ADDENDUM #4

**PROJECT: BATON ROUGE POLICE DEPARTMENT TRAINING ACADEMY RENOVATIONS
CITY PARISH PROJECT NO. 21-ASC-CP-1446**

BRPD Training Academy Renovations
9000 Airline Hwy, Baton Rouge, LA 70815
Engineer Project Number : 22-163

ADDENDUM #4

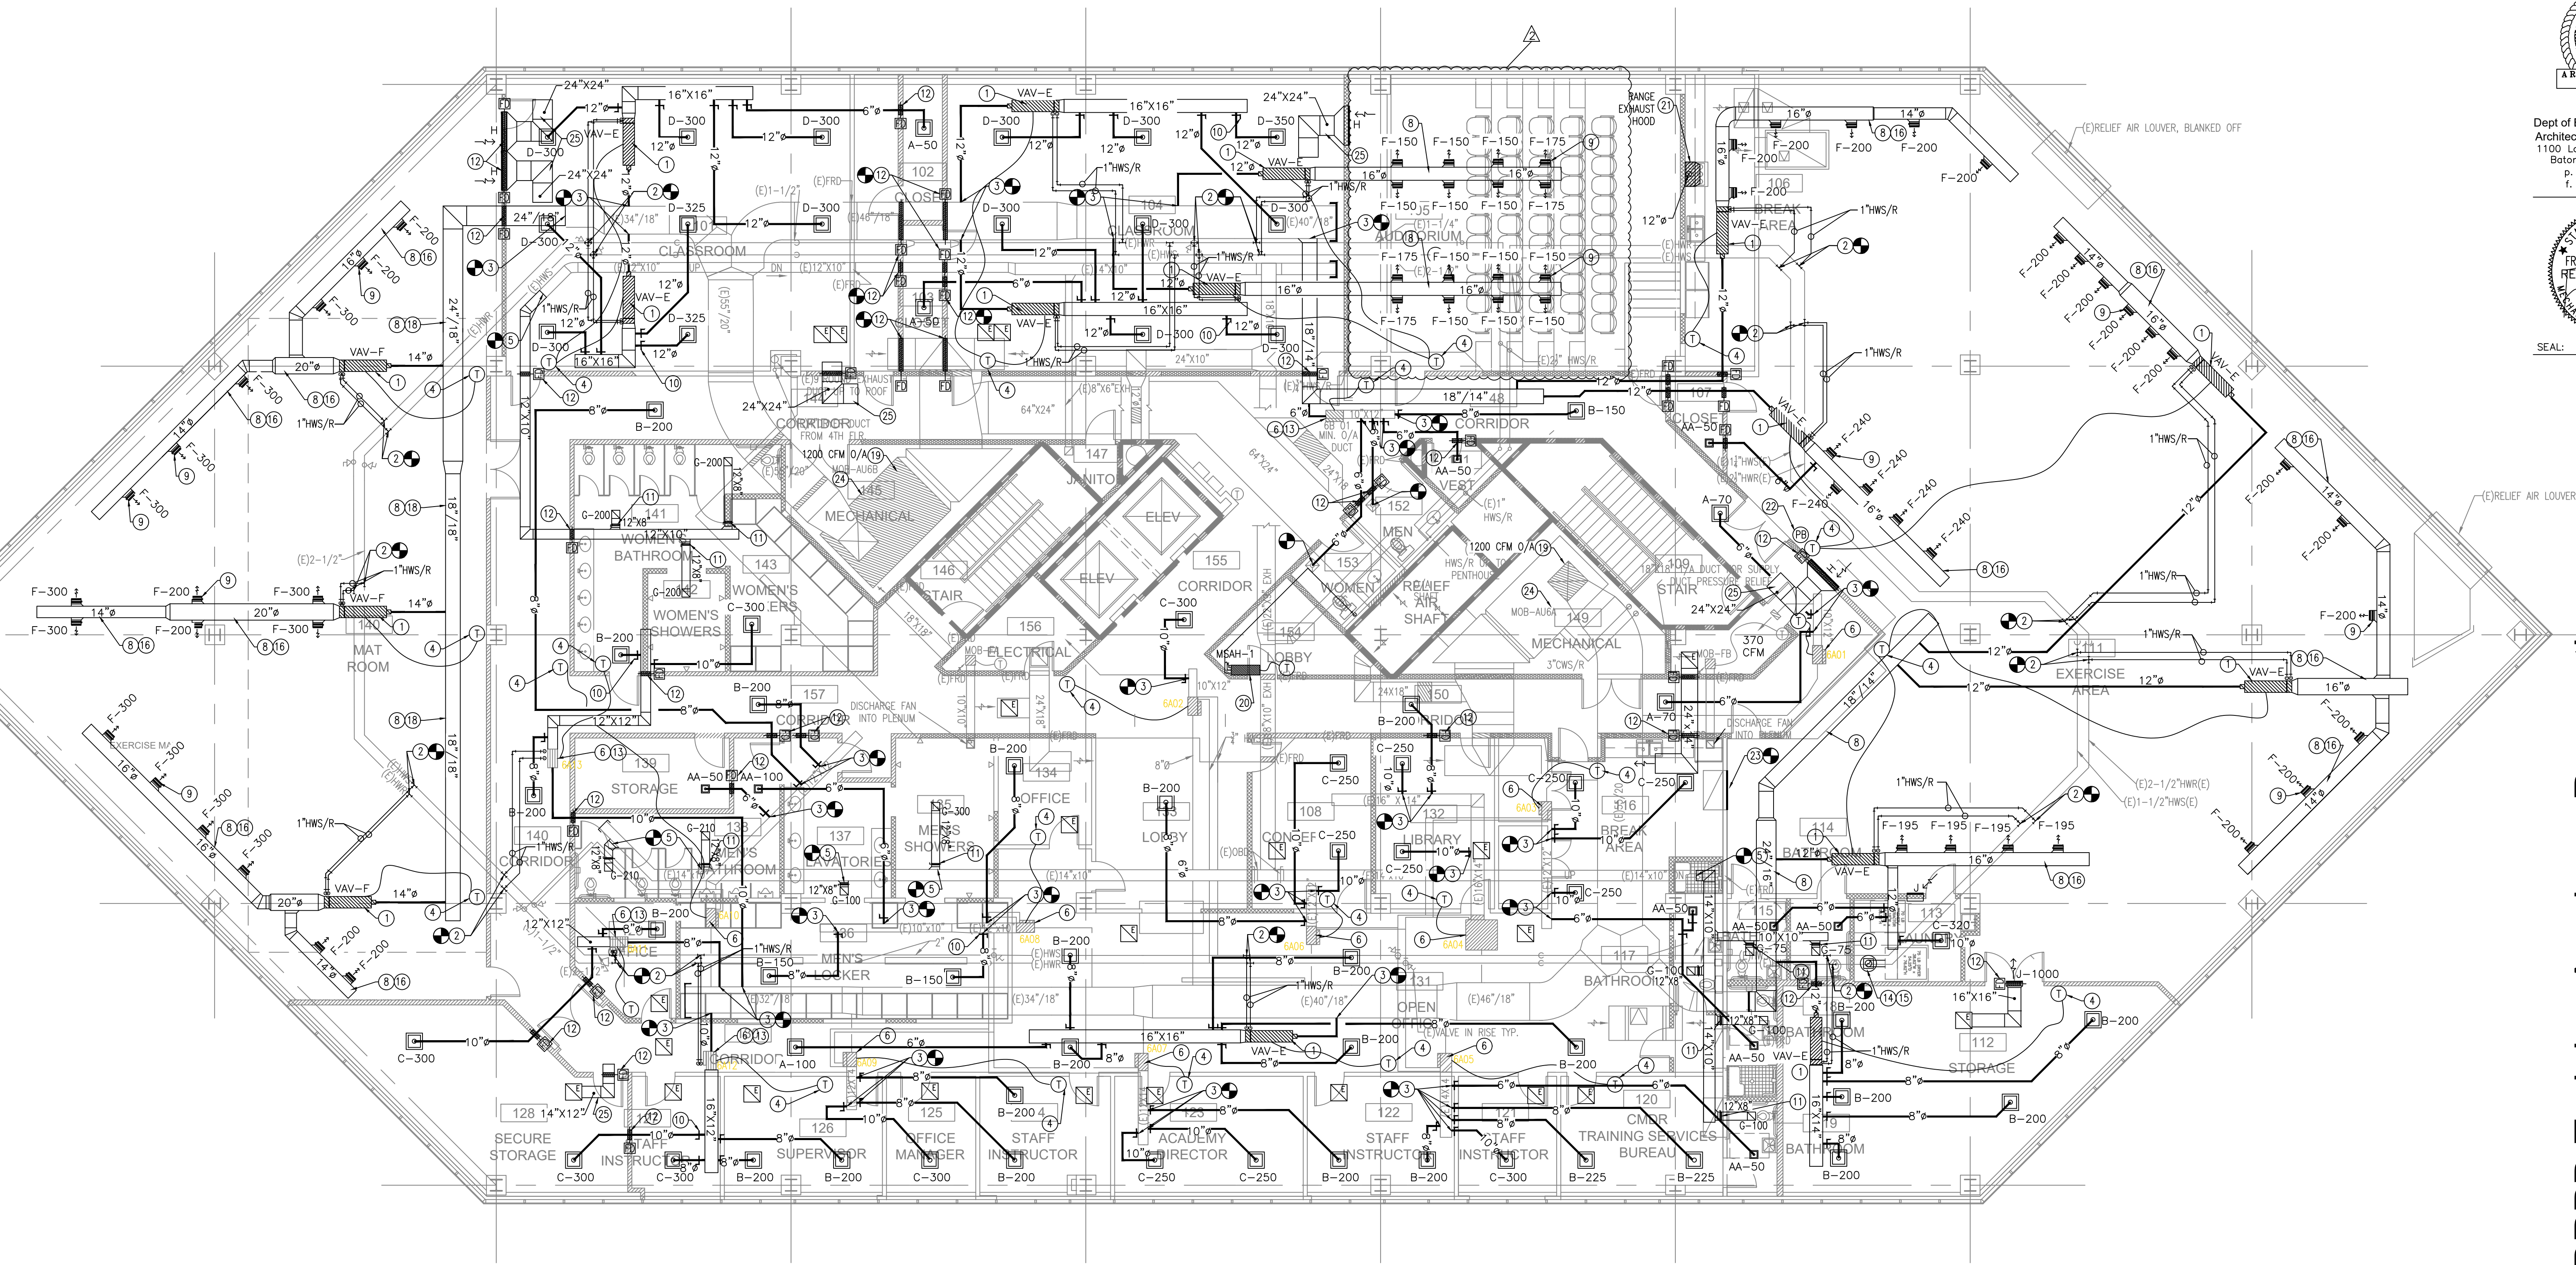
1. Contractor shall provide VLUC3-B-36L-120V (4) undercabinet lights or approved equal in Break Area 106. Space fixtures evenly under two sections of cabinet. Provide (1) SPST switch (1) ¾" Conduit, 2#12 THWN, and 1#12 GND as required landed on breaker 54 on panel "P6B".

Mechanical Plan

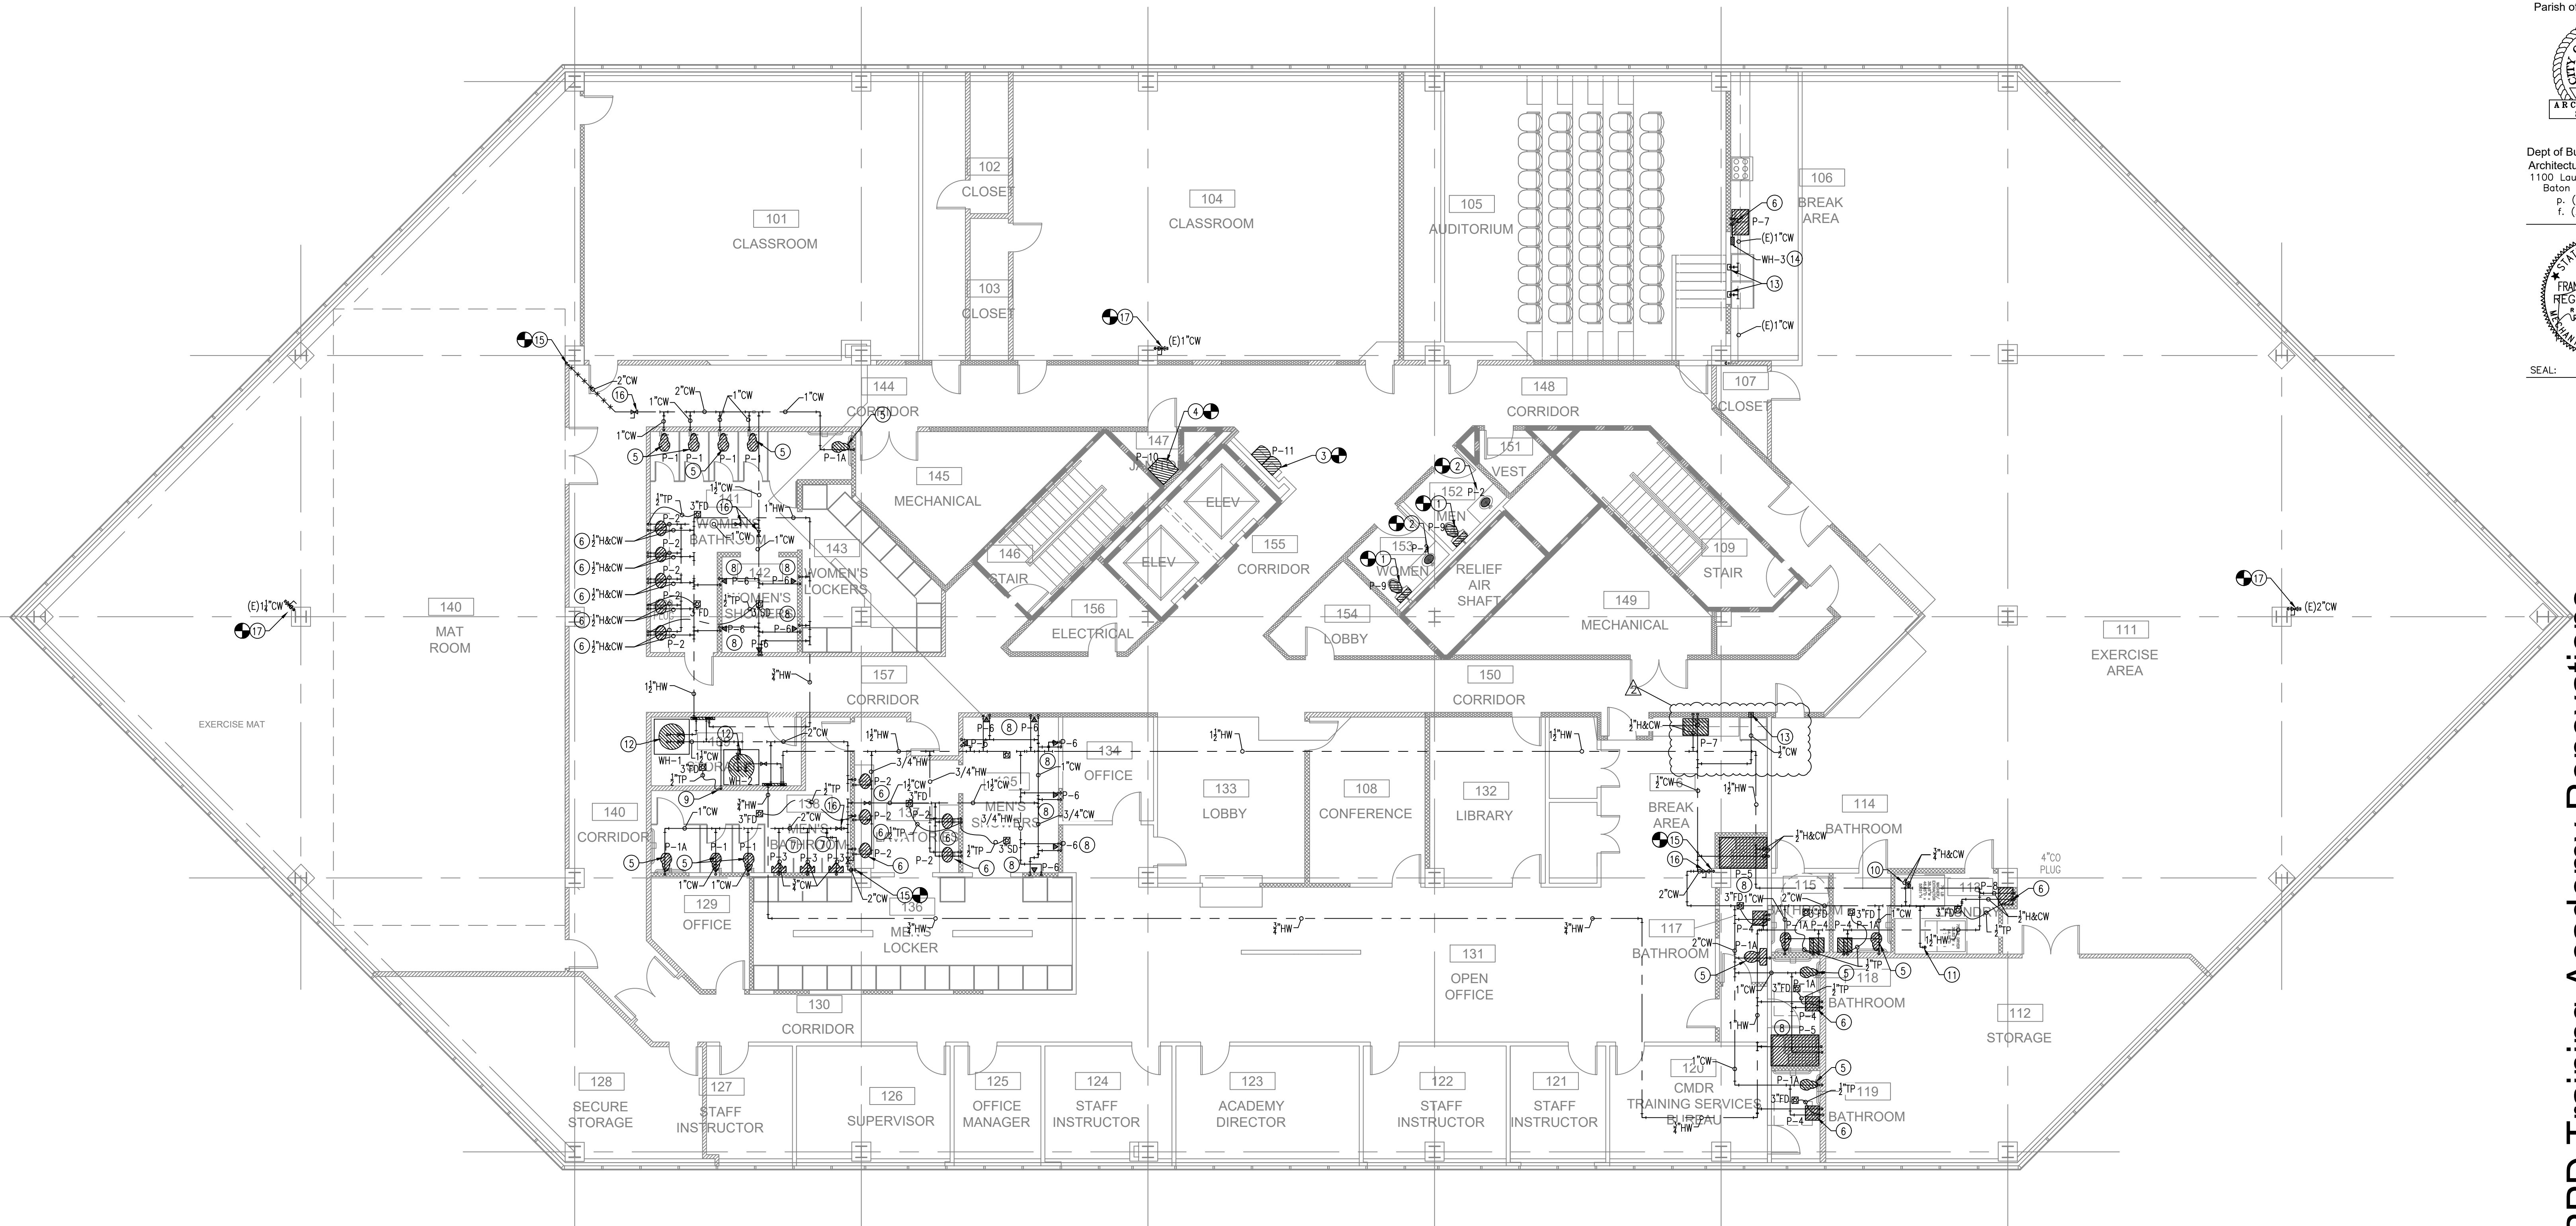
1. M1.2 Mechanical Plan
 - a. Reduced spiral ductwork in Auditorium. Route ductwork as high as possible. Coordinate exact mounting with lighting. Ductwork shall be installed above the lighting.
